S E R V I C E N O T E

Agilent 4294A Precision Impedance Analyzer

Serial Numbers: JP1KG00101 / JP1KG00350

ADMINISTRATIVE INFORMATION

Figure 1. AC Inlet Connector

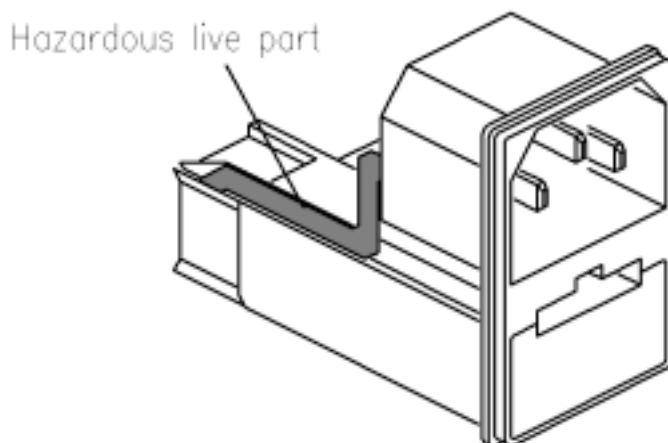
The AC inlet (P/N 1252-6951) has the potential to slip out of the instrument's rear panel slot if the AC power cord is forcefully pulled in a diagonal direction. When this happens, an exposed connection on the AC inlet module may touch the rear panel of the instrument and cause an electrical short if the AC power cord is still connected to the AC power outlet. See Figure 1.

In the worst case, there is also a possibility of an electric shock hazard to the user if the user completes a circuit between the instrument panel and another grounded connection while the AC power cord is still connected to the AC power outlet.

- Remove the AC power cable from the AC power outlet and the product.
- Remove the top, bottom, and side covers.
- Seal the hot line terminal on the AC inlet with silicon paste (P/N 5183-4112).
- Reinforce the connection between the AC inlet and the rear panel with silicon paste.
- Perform Self Test to verify instrument operation.

- Remove the AC power cable from the AC power outlet and the product.
- Remove the top, bottom, and side covers.
- Replace the rear panel assembly with P/N 04294-00213.
- Install the new fuse P/N 2110-1303.
- Perform Self Test to verify instrument operation.
